WATER DISTRIBUTION SYSTEM

STAR LUMBER

3601 W. WALKER ST.

AS BUILTS	
Contractor:	Project Inspector:
Ewertz Excavation	Larry Gann
3/28/2023	
117 E. Lewis, Wichita, KS 67202 (316)264-0242

LINE 1

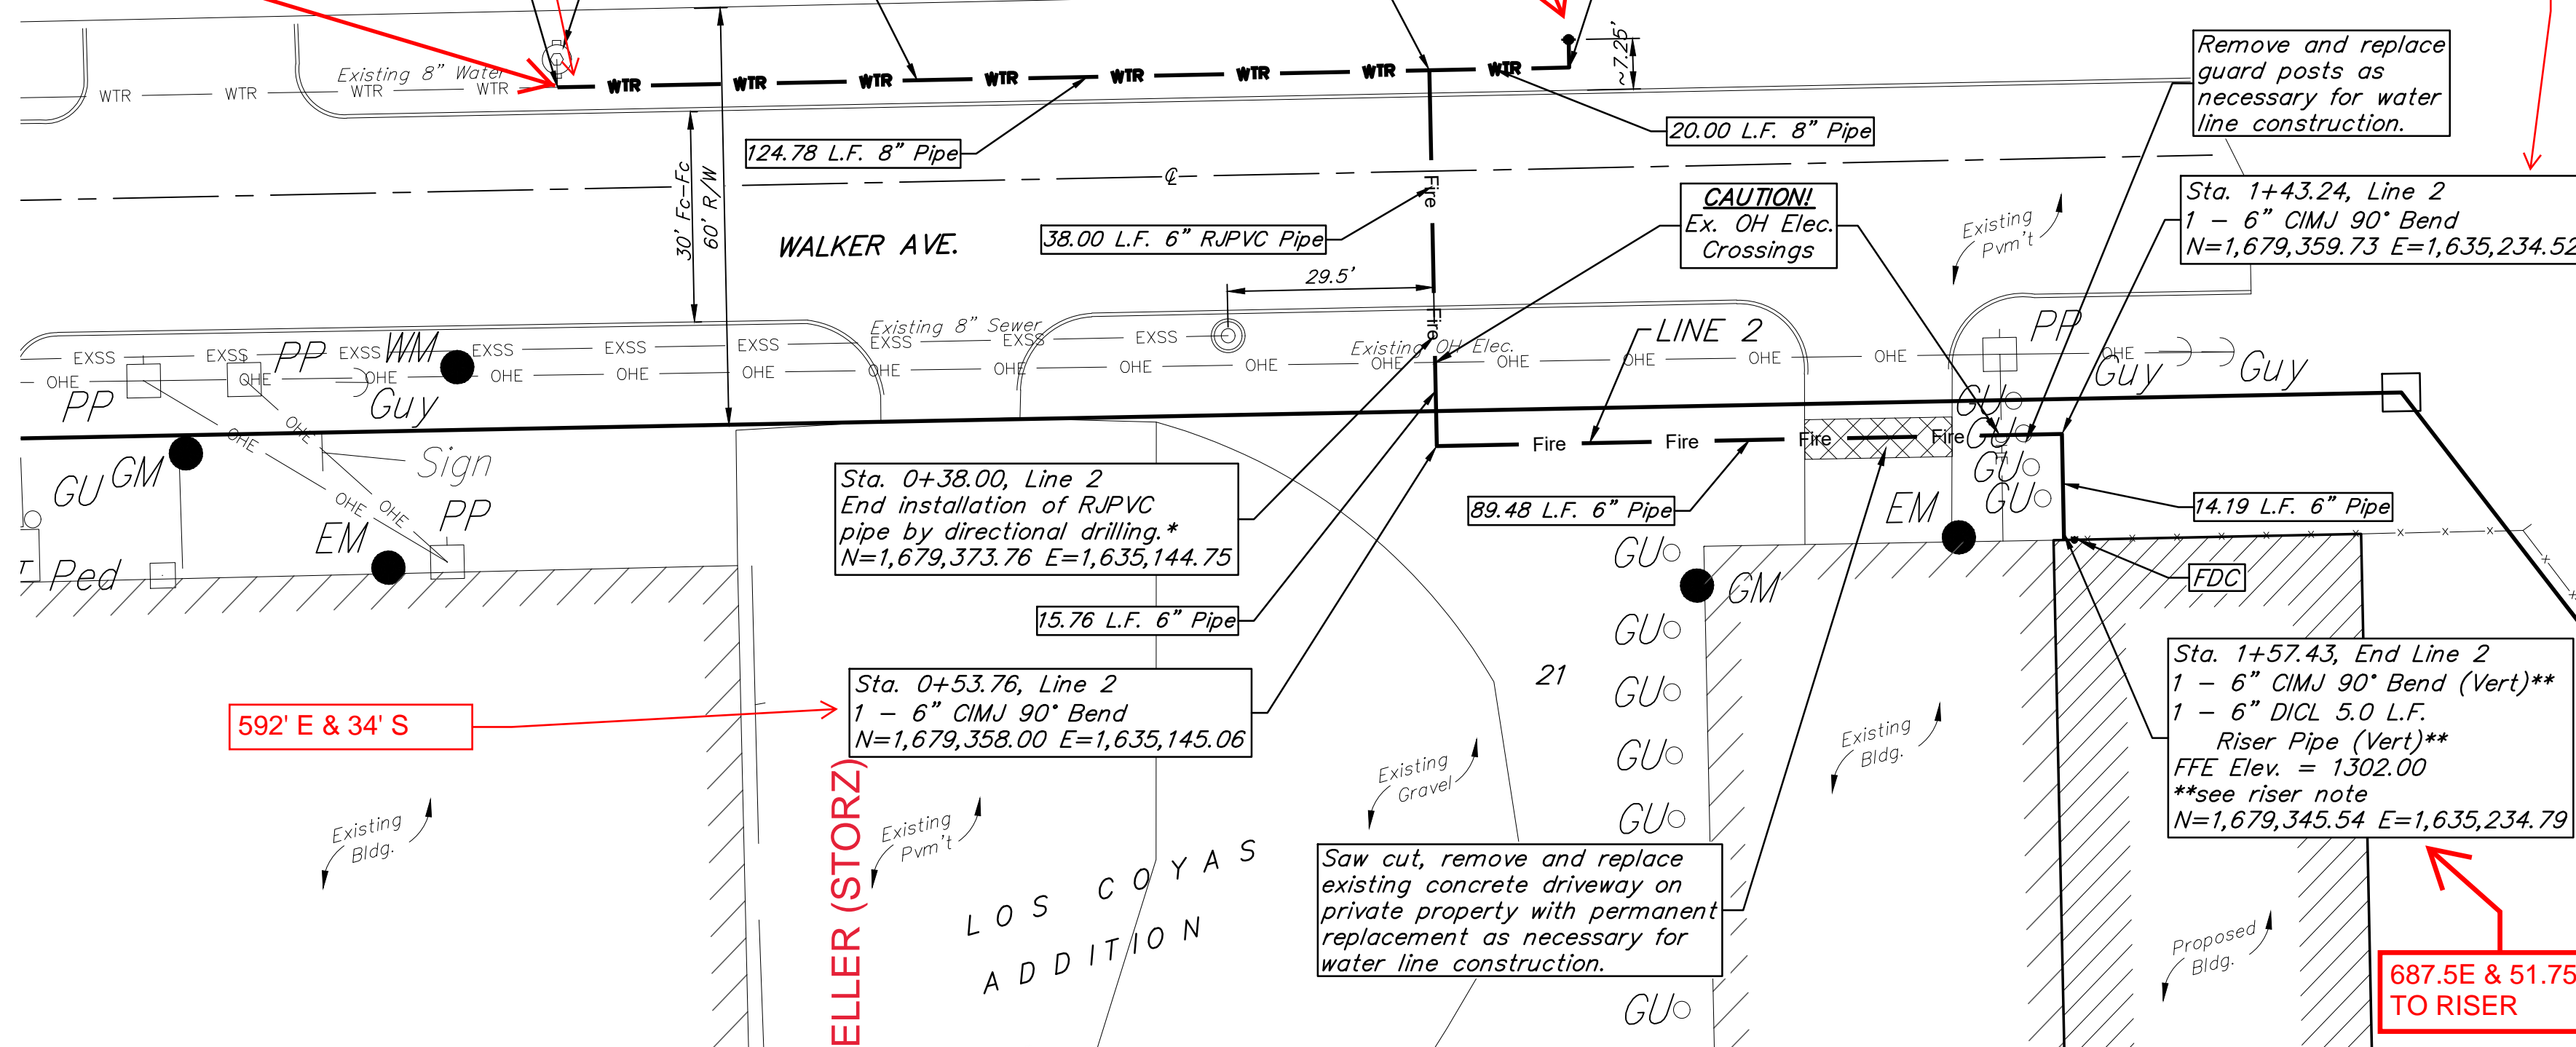
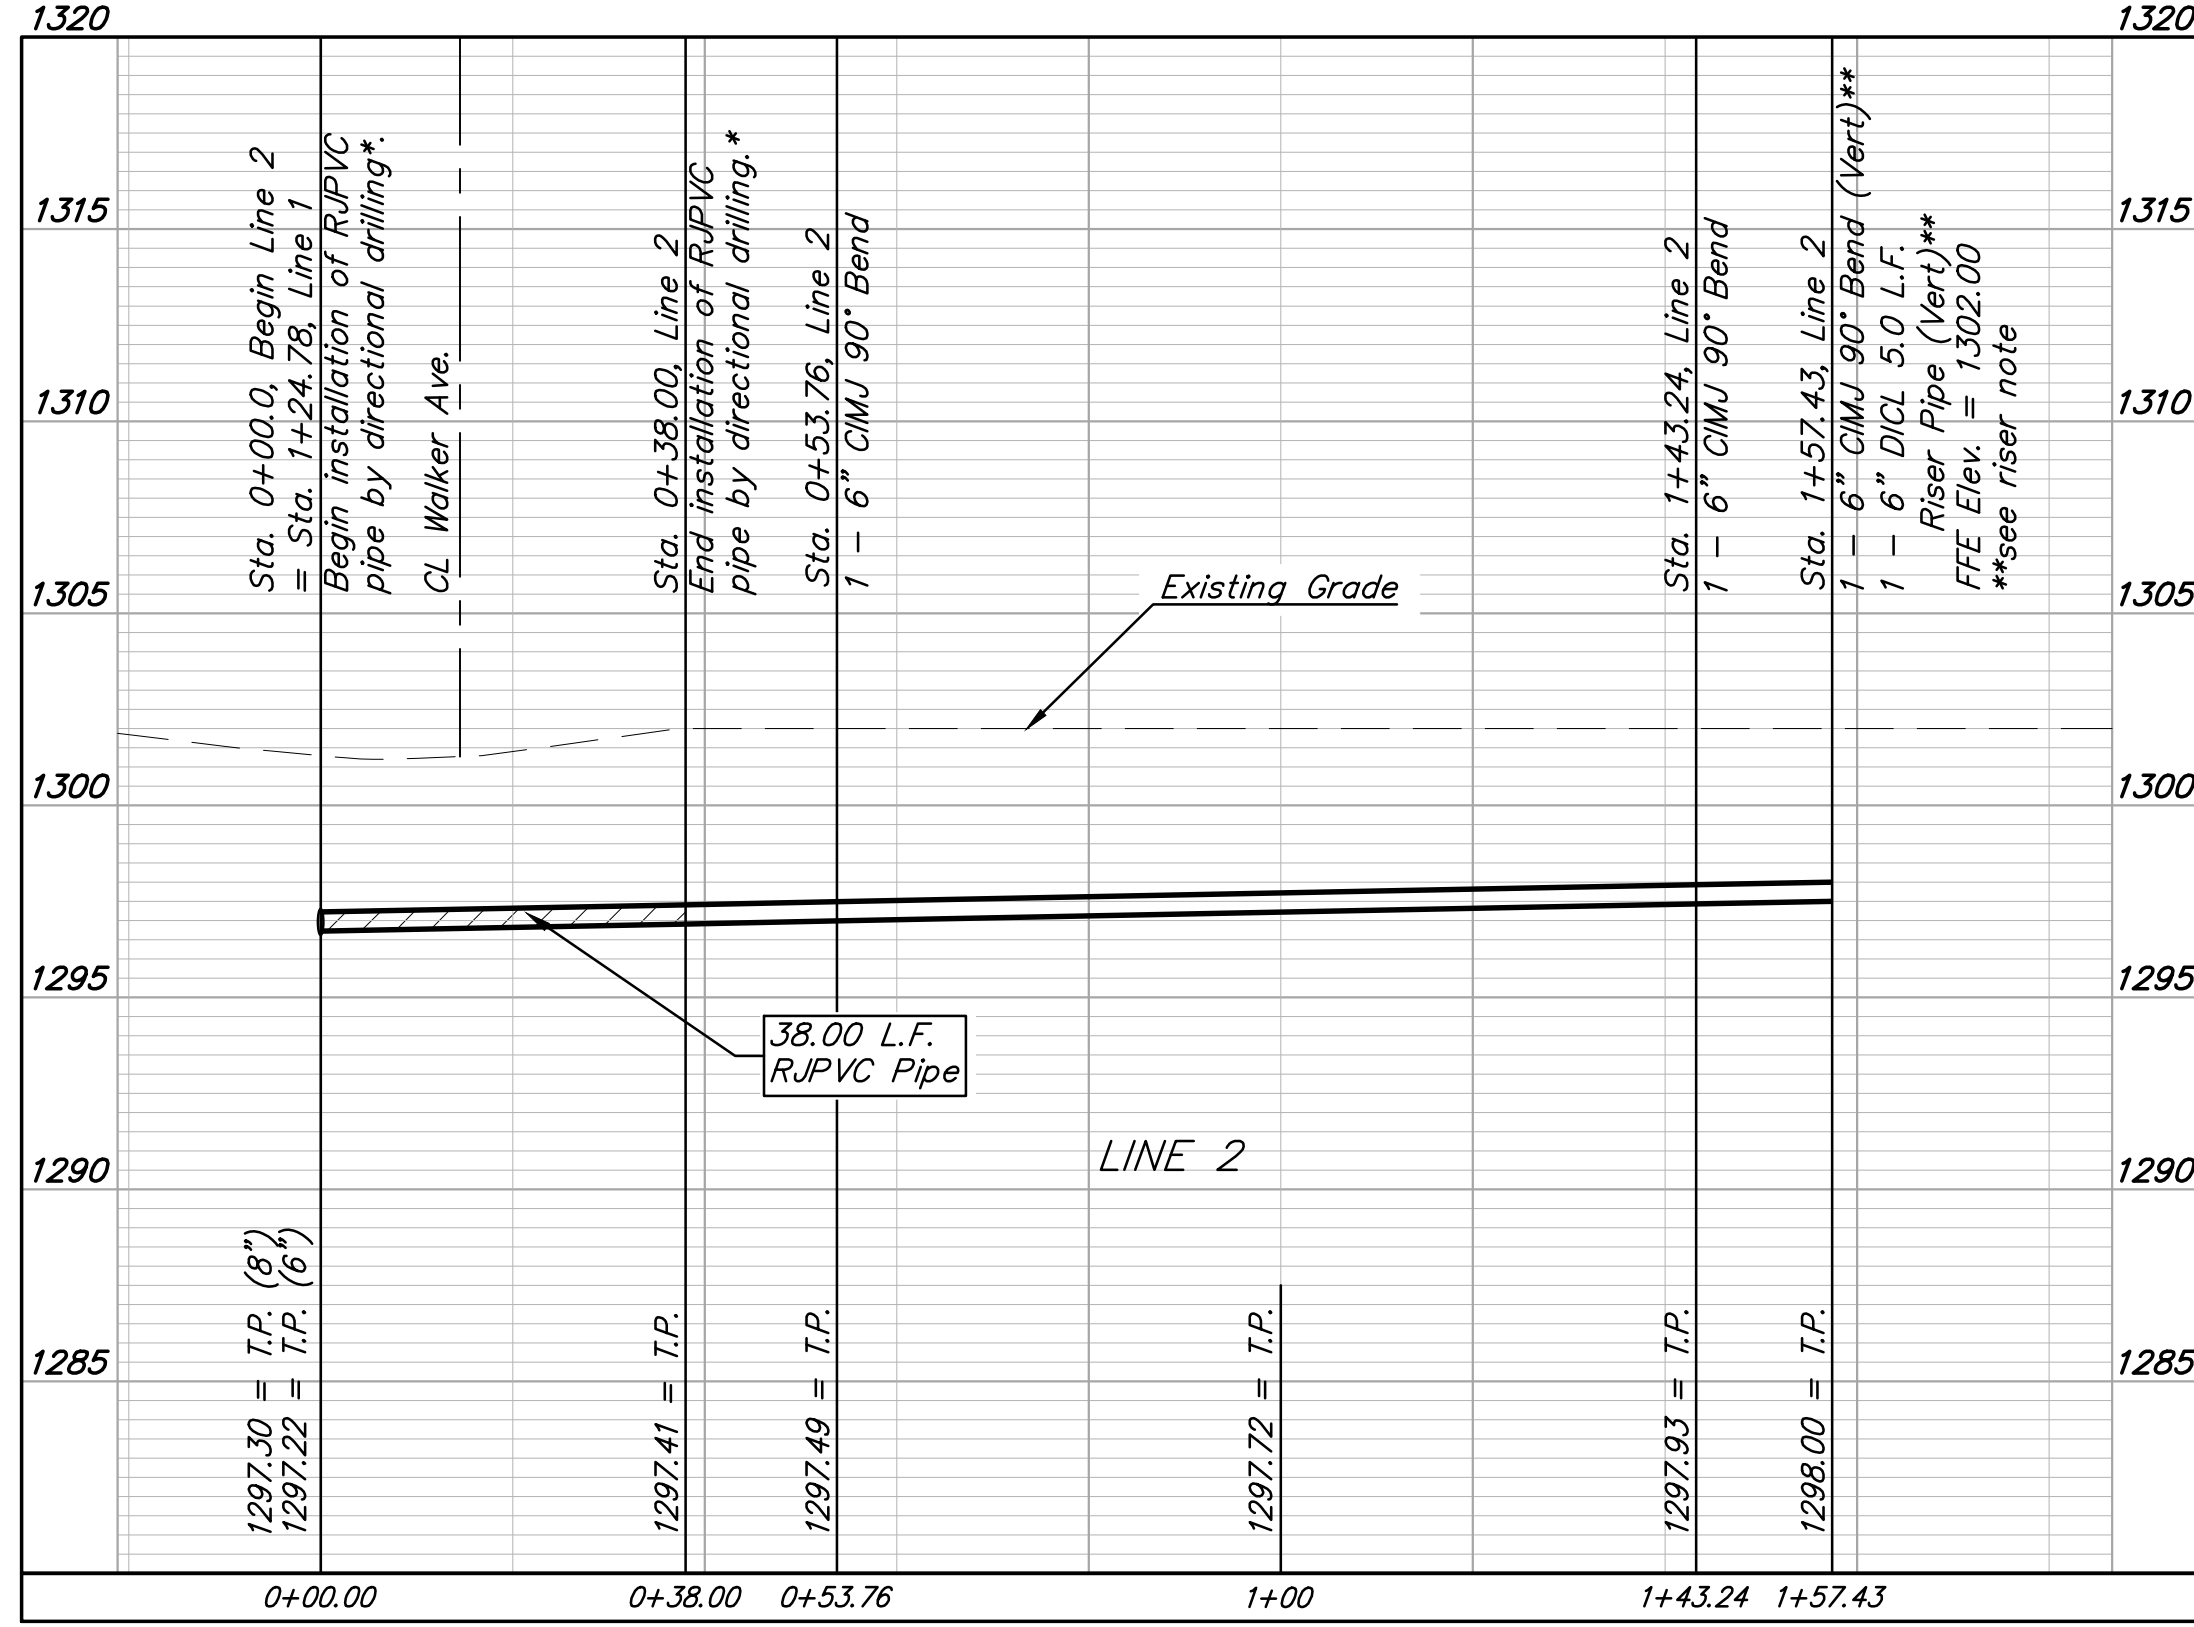
*All connections to
directional drill pipe
must be restrained joint

FH MOVED
1'10" west
